UNITED STATES NUCLEAR REGULATORY COMMISSION'S  
ADVISORY COMMITTEE ON REACTOR SAFEGUARDS

Title: Advisory Committee on Reactor Safeguards  
ESBWR Subcommittee: OPEN SESSION

Date: Thursday, October 22, 2009

Figure 7.3-8

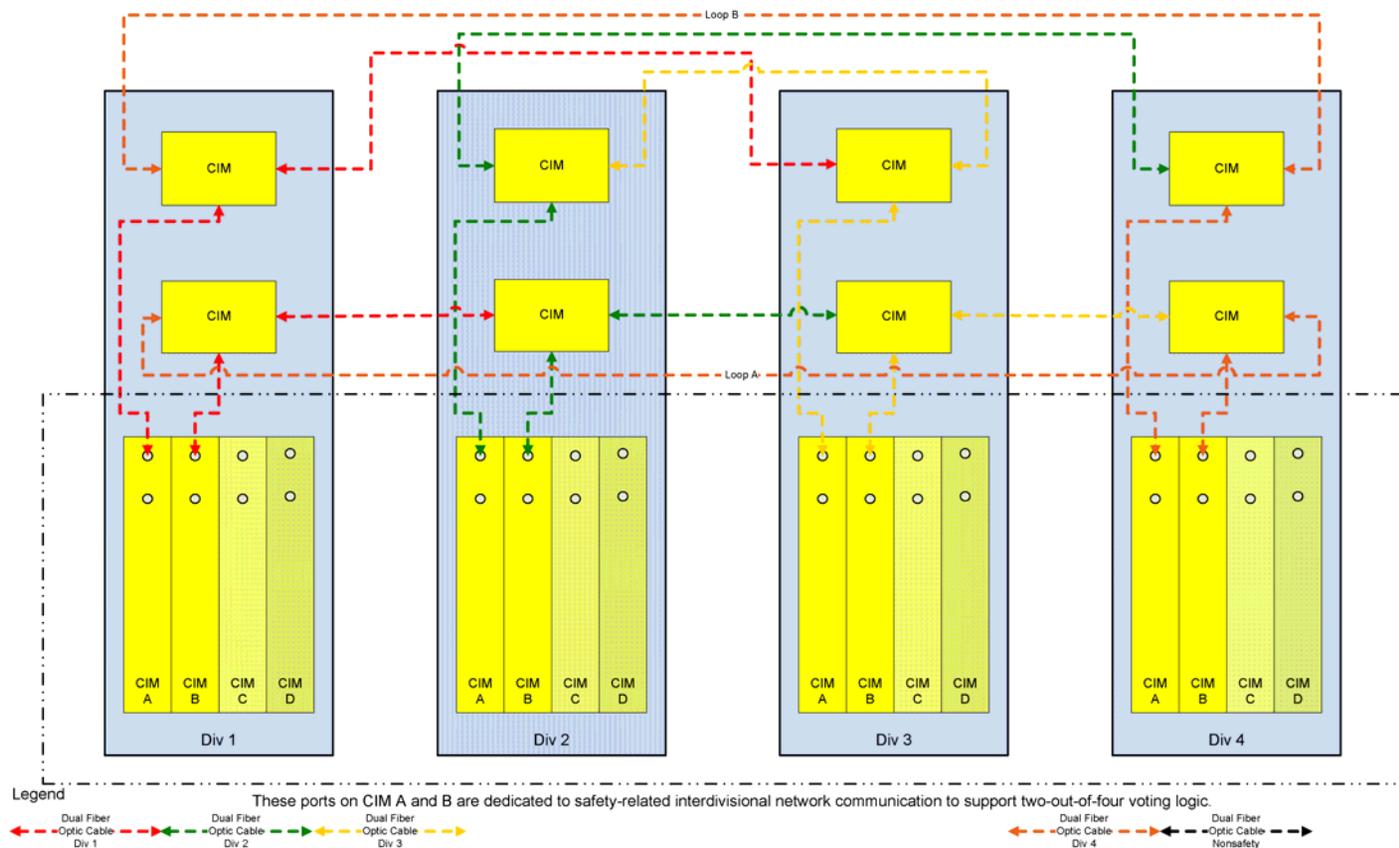
19 In the next slide, we'll show the diverse  
20 communication network protocol for the SSLC/ESF. If  
21 you go to the next slide, which is 2 of 2. So, again,  
22 we have to have a way for the is SSLC/ESF to perform  
23 the two-out-of-four voting. We are using Ethernet to  
24 do that, and the way in which we assure that this  
25 protocol and media is deterministic is to control what

2 So, the message and its content size and  
3 the transmit rate that is required in order to achieve  
4 the response time for the functions that's being  
5 implemented. So, here we have an Ethernet network.  
6 It's 100 megabits or more, depending on when we  
7 implement the first one. And it only is running an  
8 infinitesimal amount of data so that for all practical  
9 purposes, collisions or the probability of a collision  
10 is infinitesimal. So, this will always deliver the  
11 message between the divisions.

Derived from DCD Rev. 6 Figure 7.1-1 ESBWR Instrumentation and Control DCIS Simplified Network and Functional Block Diagram

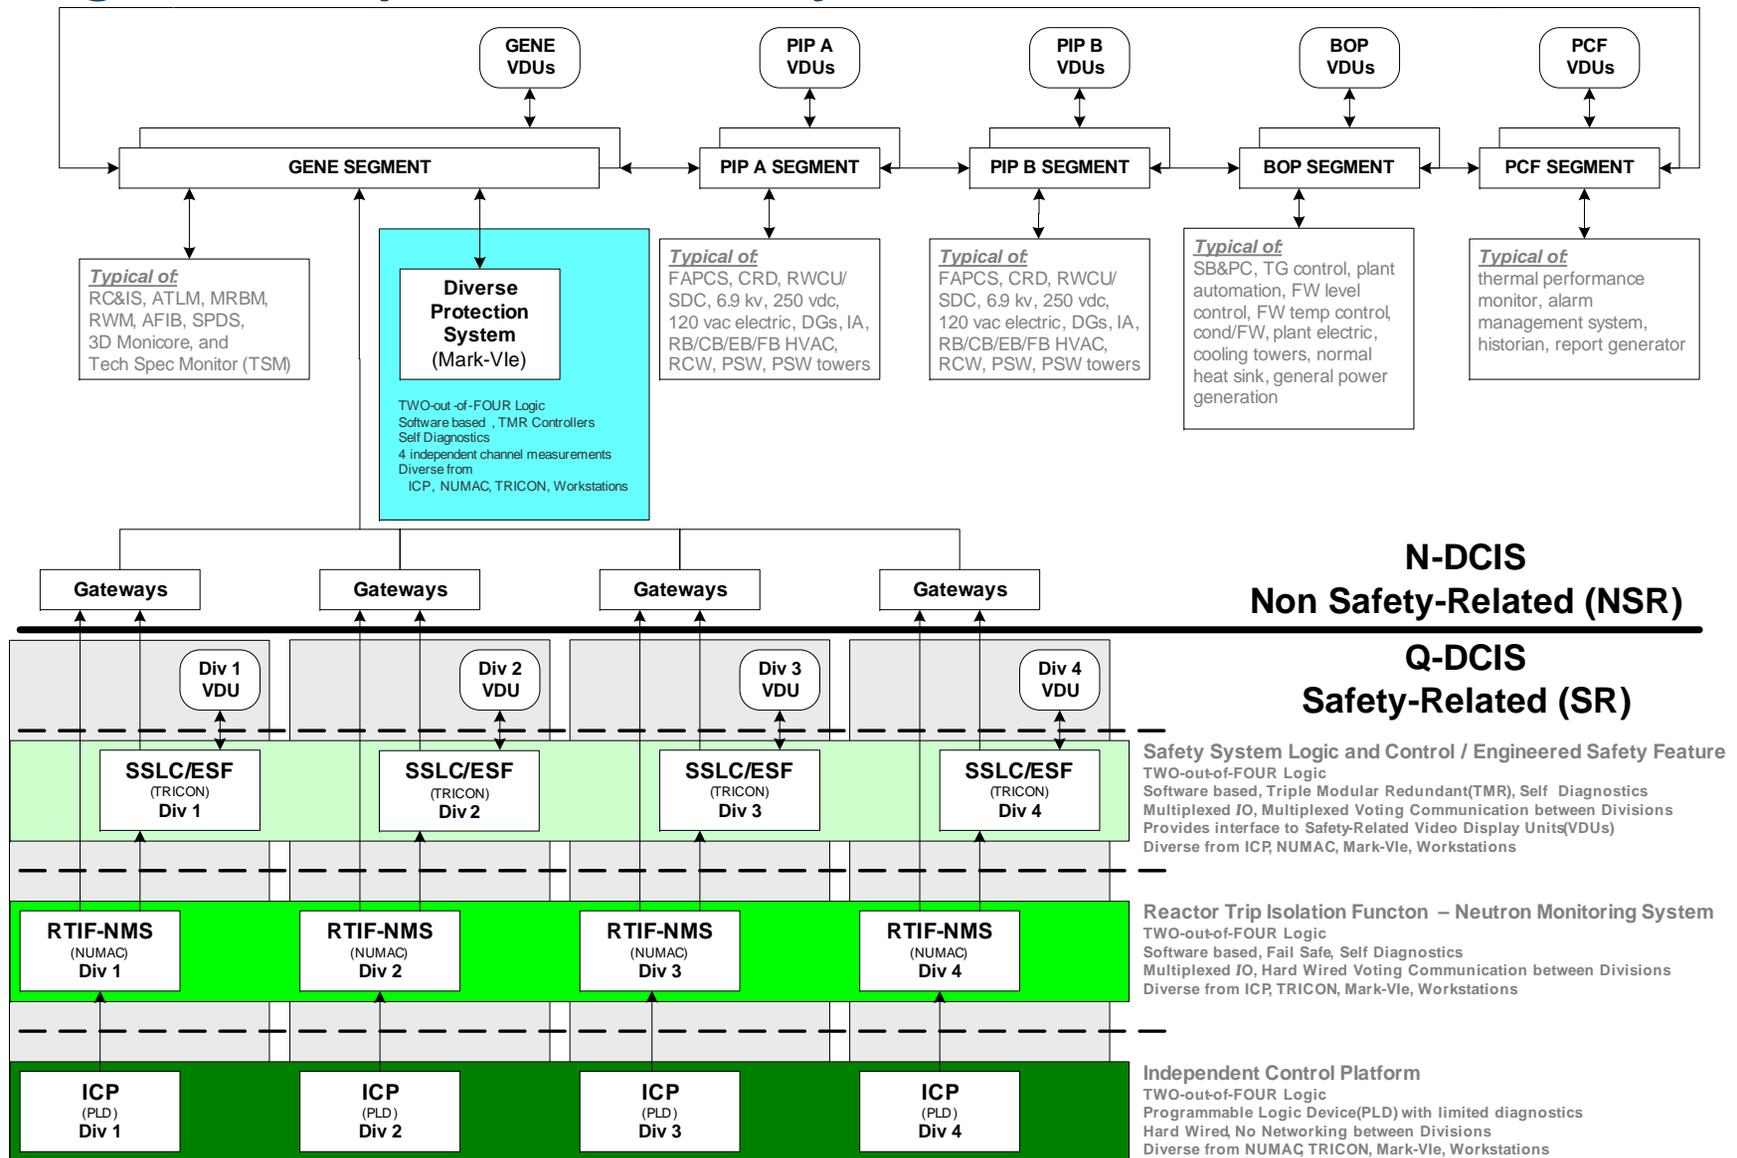
17 So, if you go to the next slide, what  
18 we've tried to do here is bring this into a derivative  
19 graph of Figure 7.1-1. So, here, we're presenting the  
20 horizontal layers to clearly communicate that the  
21 ICP's in dark green, they are microprocessor and  
22 operator -- operating system-free implementations and  
23 programmable logic.
